October 2, 2014

SUBJECT: REQUEST FOR CLARIFICATION RELATED TO THE WESTINGHOUSE MULTI VENTURI SCRUBBER SYSTEM (FILTRA-MVSS) AND DRY FILTER METHOD (DFM) TO SUPPORT THE CONTAINMENT PROTECTION AND RELEASE REDUCTION FOR BOILING WATER REACTOR WITH MARK I AND MARK II CONTAINMENTS RULEMAKING

Mass Fraction Distribution Chart

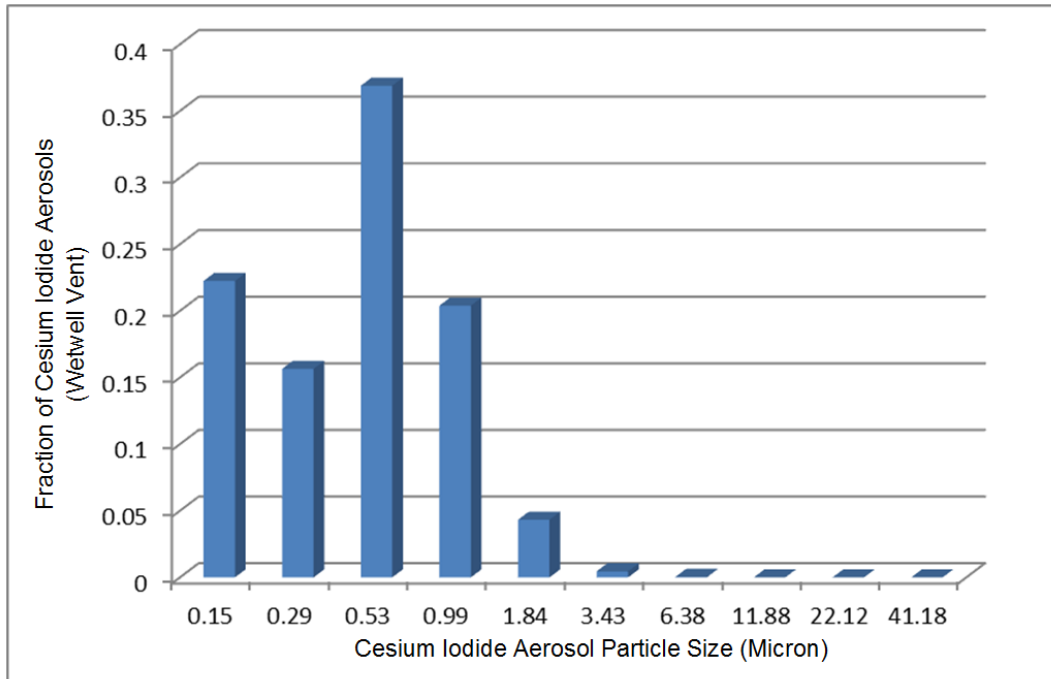
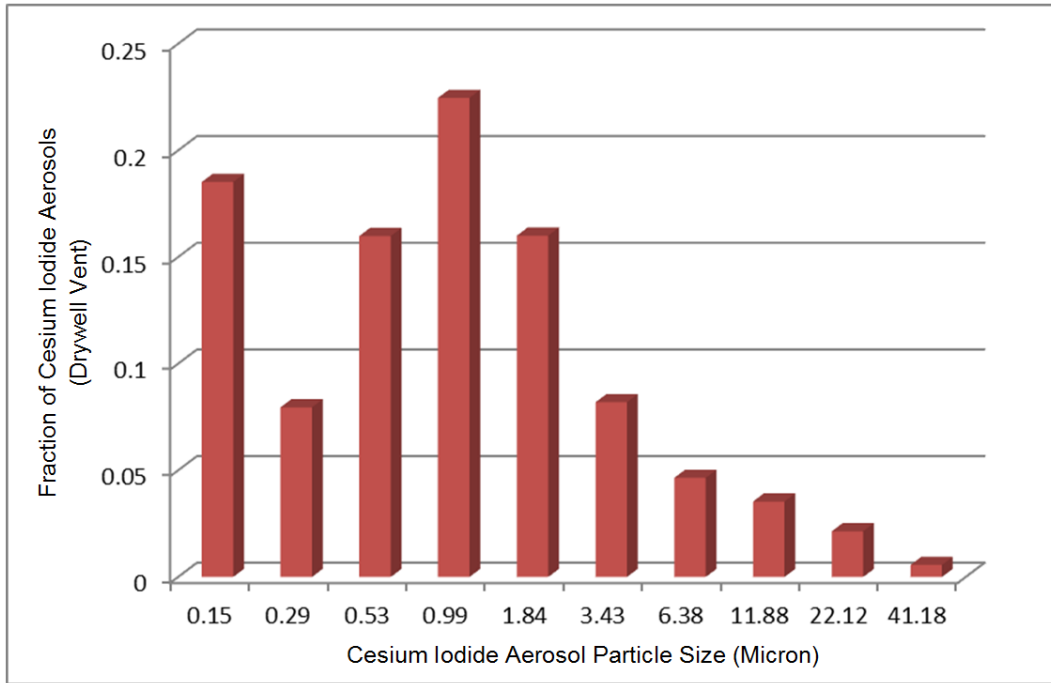
The NRC staff's analyses of certain severe core damage accidents caused by an extended loss of AC power have shown that the particle size spectrum reaching the filter is dominated by particles less than one micron Aerodynamic Mass Median Diameter. Example mass fraction distributions of Cesium Iodide (CsI) reaching the wetwell and drywell vents are shown in the enclosure. Thus, these particle sizes determine the actual effectiveness of the engineered filter in the application we are assessing. The NRC staff is unable to determine the decontamination factors (DF) for these particle sizes from the integrated DF values and design descriptions provided in Westinghouse's presentation to the NRC staff. It would benefit the NRC staff if Westinghouse provides the DF by the particle size in the range shown in the enclosure, broken down if possible by the contribution from each stage in the filter (e.g., venturi, pool, and demister for FILTRA-MVSS), and by appropriate stages of the dry filter method (DFM).

The NRC staff is also requesting the detailed basis for the DF values you provide (i.e., experimental data and modeling). This information is necessary to respond to the Commission's direction to provide the validation and testing needed should an engineered filter be included in the requirements of the rulemaking.
